SUBJECT: **Safety Recall 16S41 – Supplement #1**
Certain 2010-2012 Model Year Escape and 2010-2011 Model Year Mariner Vehicles
with a 3.0L Engine
Fuel Delivery Module Flange Replacement

REF : Safety Recall 16S41
Dated: August 29, 2017

New! REASON FOR THIS SUPPLEMENT

Technical Information: Notes have been added to the technical instructions to help prevent long crank or hard start concerns that can result from improper fuel supply tube and clamp installation.

FIGURE 4

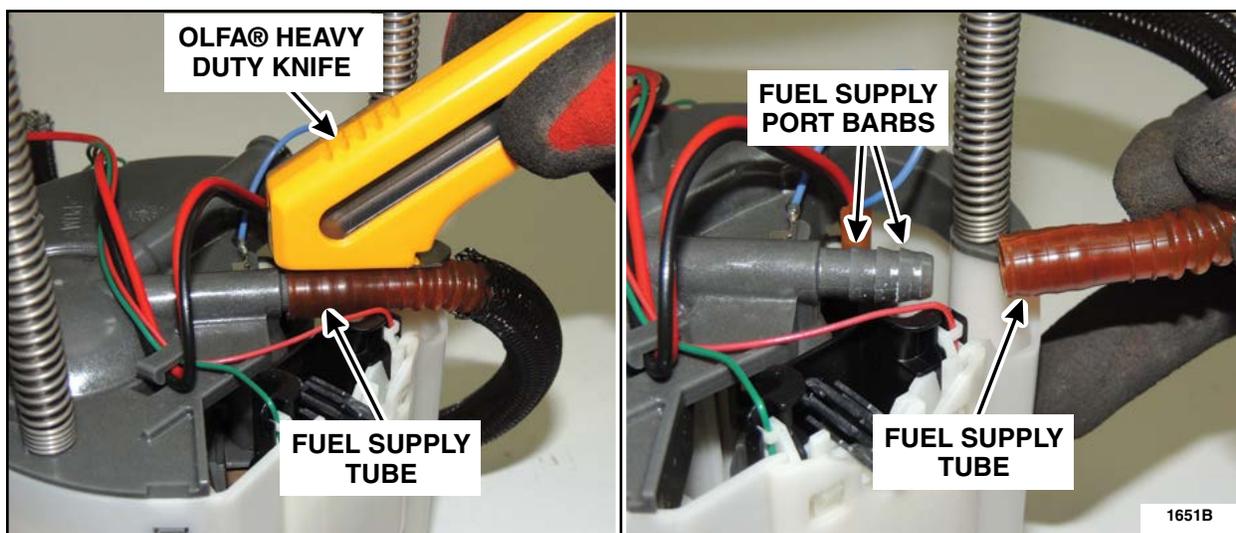
- Using an adjustable blade tool (Olfa® heavy duty knife shown) set to 1/16 in (1 mm) depth, carefully cut the fuel supply tube to release it from the supply port. See Figures 3 and 4.

NOTICE: Use caution not to cut or damage the barbs on the fuel supply port when cutting the fuel supply tube.

NOTE: Cut or damaged barbs on the fuel supply port may result in a long crank or hard start concern due to fuel pressure bleed down.

FIGURE 8

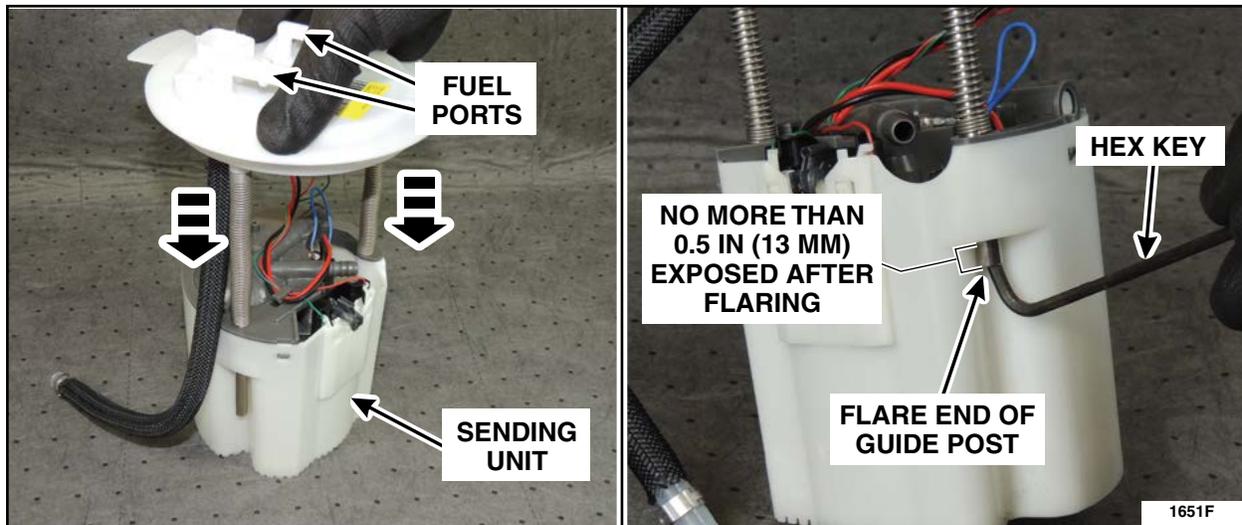
8. Install the *new* FDM flange, paying close attention to the proper orientation of the FDM flange to FDM. See Figure 8.

NOTE: When installing the *new* FDM flange, the flange must be aligned properly so the ports are pointing towards the sending unit side of the FDM.

NOTICE: When flaring the end of each guide post, only apply enough pressure to prevent the guide post from pulling through the lower module. Using excessive pressure when flaring may cause bending of the guide post, which can limit the necessary travel of the flange. The flared guide post should look similar to Figure 5, and no more than 1/2 in (12.7 mm) of the guide post should be exposed on the bottom side of the FDM after flaring.

FIGURE 9

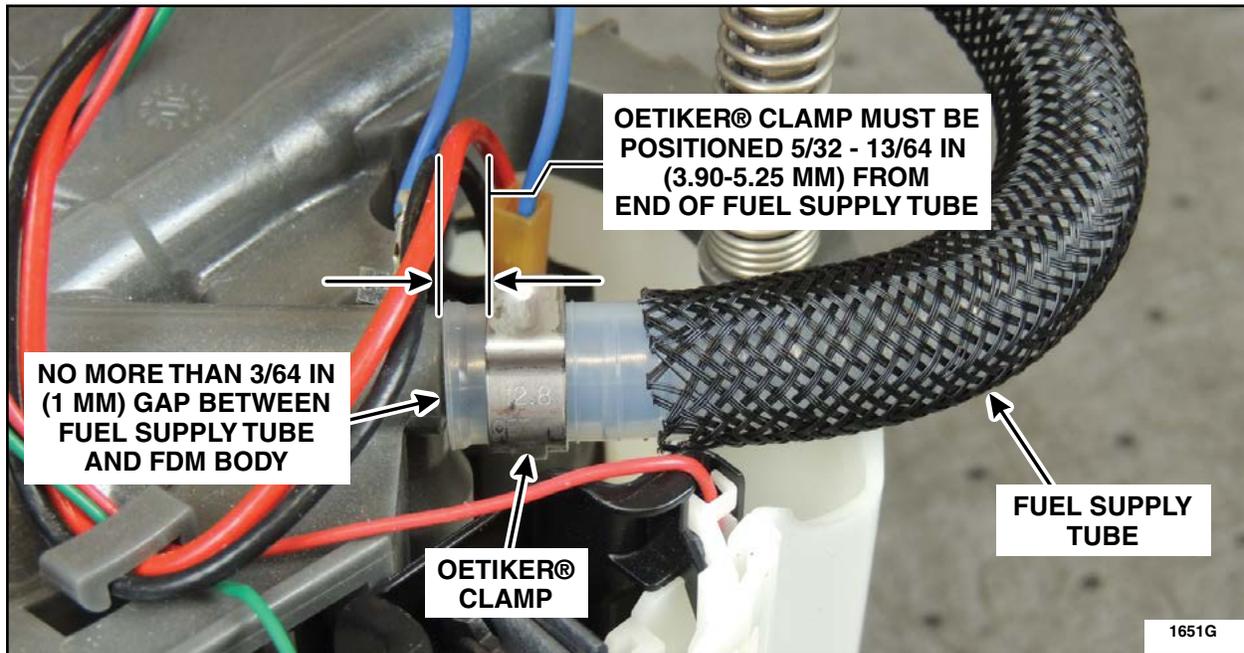
9. Connect the new fuel supply tube to the supply port and tighten the Oetiker® clamp using Oetiker® clamp pliers. See Figure 9.

NOTE: The Oetiker® clamp must be positioned properly and tightened using Oetiker® clamp pliers only. Do not use side-cutter pliers to tighten the Oetiker® clamp. If the fuel supply tube or clamp are not positioned properly or the clamp is tightened using anything other than Oetiker® clamp pliers, this may result in a long crank or hard start concern due to fuel pressure bleed down.
